P5024A-03A-S

Safety Service Note

P5024A Keysight Streamline USB Vector Network Analyzer

“POTENTIAL BURN INJURY (HIGH TEMPERATURE) HAZARD”

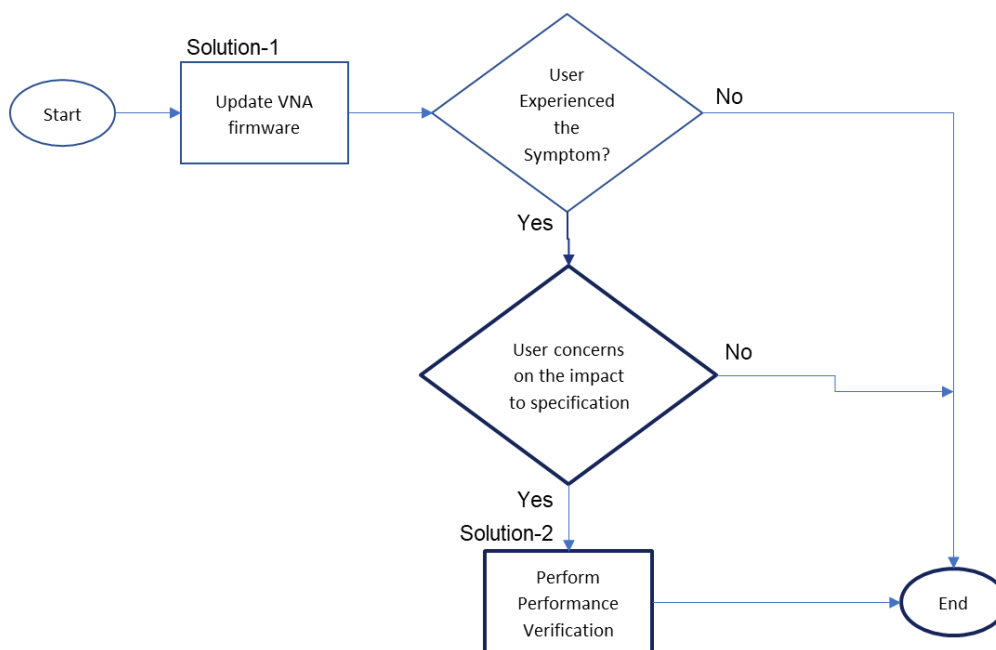
VNA fails to start with the following symptoms.

1. LED indicator (below circle) turns red.
2. cooling fan does not work
3. If user leaves the VNA with this LED indicator red without turning off power switch, it continues to overheat and becomes too hot.

Solution-1: Update VNA firmware by user

Solution-2: Perform Performance Verification by Keysight

1. **Install the latest VNA firmware Rev. A.15.55.14 or newer** on users' controller PC(s).
The latest firmware enhanced the thermal fan control mechanism.
2. Once the latest firmware is installed, proceed with the restart of both **controller PC** and **VNA**.
3. Launch the VNA firmware. Ensure VNA powers up and launches into firmware correctly after firmware update is done.
